EXHIBIT 1.A: Engineering/Public Works Staff Report Memo and Conditions of Approval

Subject: Preliminary Plat Engineering Staff Report | Pinnacle at Liberty Bay PRD | P-06-20-25-03

Date: November 5, 2026

Proposed Site Plan (Exhibit 2.b):

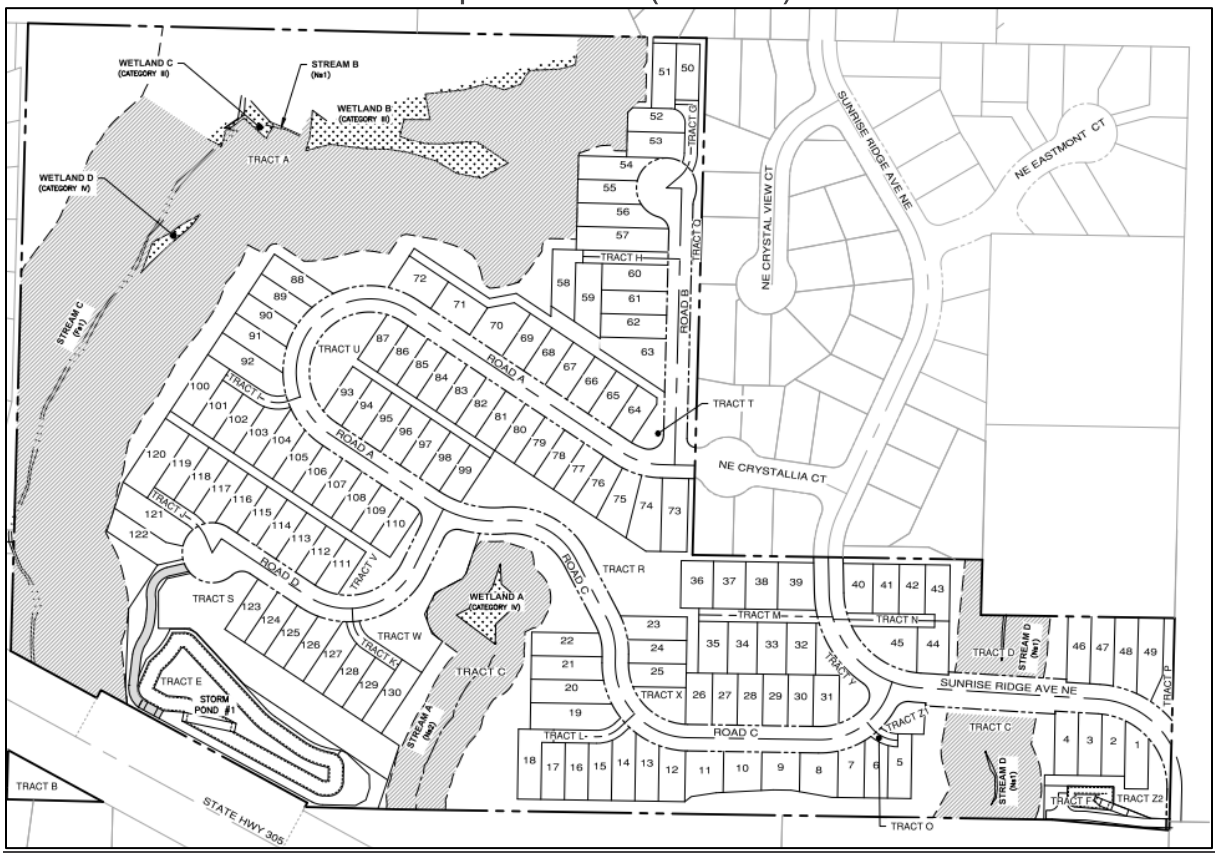
The proposed Pinnacle at Liberty Bay PRD as proposed is a residential subdivision comprising 130 detached single-family lots. Improvements include domestic water, sanitary sewer, public roads, utility services, open space, recreational amenities, pedestrian walking paths, and stormwater management facilities. The roughly 41-acre site is located north of SR 305 and will be developed in phases. Several types of critical areas are present on the property, including wetlands, streams, and associated buffers. Access is planned from NE Crystallia Court and Sunrise Ridge Avenue NE. The

project will access from Jonhson Parkway NE via extension of Sunrise Ridge NE. New public rights-of-way internal to the project include one residential collector road (Road A), two residential access roads (Roads B and C), and one stubbed residential access connection to serve properties to the north (Road D). Five private access tracts are proposed to each serve nine or fewer lots.

The City has determined that a public roadway connection between the project and Baywatch Court NE, consistent with planned required roadway NR-12 is required to satisfy applicable street connectivity, circulation, and emergency-access requirements. Design, permitting, and construction of the connection to the residential collector standard is therefore required as a condition of approval. The connection will be required to comply with applicable critical area requirements including any necessary supplemental technical review, mitigation and agency permitting. Planning conditions P12 and P51 further detail these requirements. Reference Engineering SEPA cover memo dated October 29, 2026 Exhibit12.c(ii) and the supporting documents referenced in that memo for further analysis and discussion on this requirement.
